NLR-CR-2017-027 | February 2017

# Second opinion SSJ-100 noise report

CUSTOMER: SWEDAVIA AB

In 2017, CityJet wants to operate RRJ-95 aircraft to and from Bromma Airport. The commercial name of this aircraft is Sukhoi Superjet-100 (SSJ-100). Since these aircraft do not fulfil the noise limits for Bromma Airport, Sukhoi provided a report to indicate how the SSJ-100 could comply with these criteria. In this report, NLR verifies the conclusions of the Sukhoi report.

Figure 1: Comparison of engine setting versus total thrust per engine

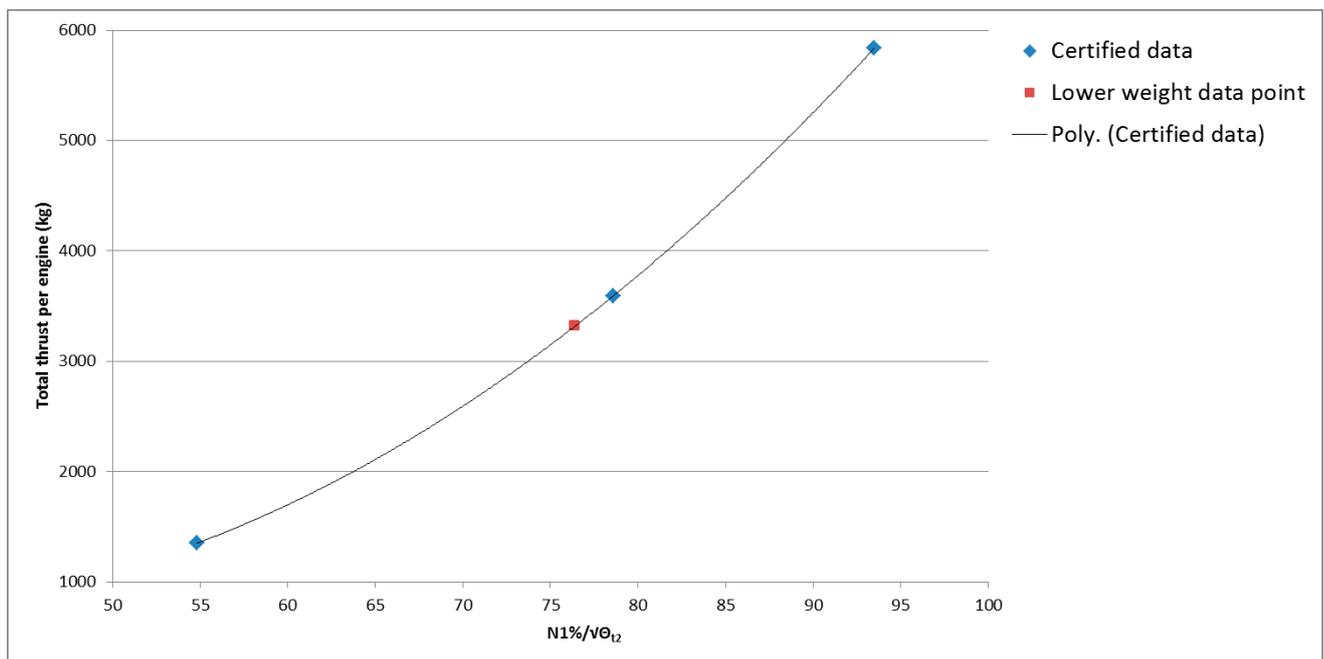
As described in the previous paragraph, the engine thrust levels for the flyover change due to the weight reduction of the aircraft. The Sukhoi report provides three certified combinations of thrust and engine setting (described with the parameter  $N1\%/V\theta_{t2}$ ). For the lower weight trajectory, one combination of these parameters is available. The certified values are plotted and a trend line is fitted through these points. After that, the data point for the lower weight trajectory is also plotted to verify whether this point is on or close to the trend line. Figure 1 shows the result of this analysis.

The figure shows that the data point for the lower weight trajectory (the red dot) is on the trend line for the other data points. This indicates that the combination of thrust and corrected N1% setting provided by Sukhoi is realistic.

Figure 2: Reduction of PNLTM noise level for an increase in flyover altitude from 2,263 to 2,575 ft

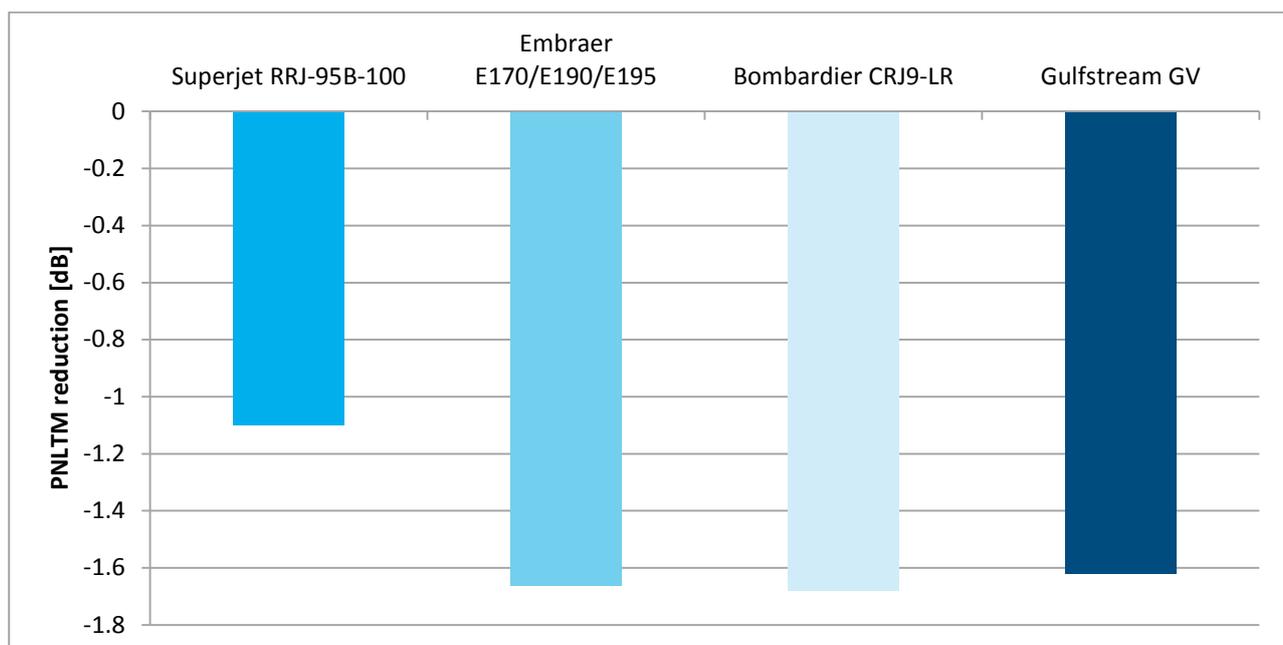
NLR prepared a global estimate of the potential effect of not including atmospheric absorption. This was done by comparing the maximum tone-corrected perceived noise level reduction as used by Sukhoi (excluding atmospheric absorption) to the noise level reduction for several similar sized aircraft types for the same increase in flyover altitude. The data for these other aircraft was obtained from the international aircraft noise and performance (ANP) database and includes the effect of (additional) atmospheric absorption. Figure 2 shows the results.

The figure clearly shows the effect of neglecting the additional atmospheric absorption. Based on these results, NLR estimates that the conservative approach as used by Sukhoi underestimates the reduction of the flyover certification noise level by approximately 0.5 EPNdB. This is only relevant for the flyover certification noise level, since the effect of absorption is fully included in the computation of the lateral and approach certification noise levels.

Figure 3: Comparison of effect of weight reduction on flyover certification noise levels

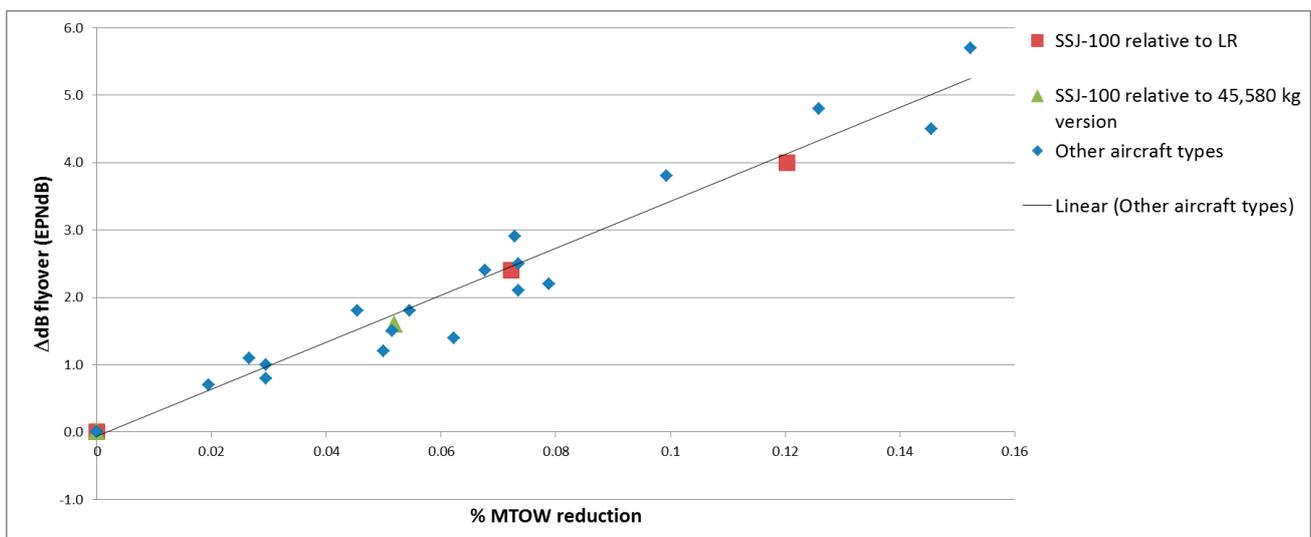
The result of the comparison is shown in Figure 3. The black line shows the average noise reduction due to a weight reduction for all aircraft types, except for the SSJ-100.

The figure shows that in all cases the noise reduction for the SSJ-100 is at or below the black line. This means that the reduction of the flyover certification noise level due to the effect of the weight reduction is average or even a little below the average of all other aircraft types. Therefore, this analysis confirms that the reduction achieved by Sukhoi seems realistic.

It should be noted that the effect of absorption (see paragraph 3.3) is not included the data points for the SSJ-100 with a maximum take-off weight of 43,500 kg in Figure 3 (the light green triangle and the most right red square). If the effect would have been included, the reduction would be larger, but would still be in line with the highest reductions achieved for other aircraft types.
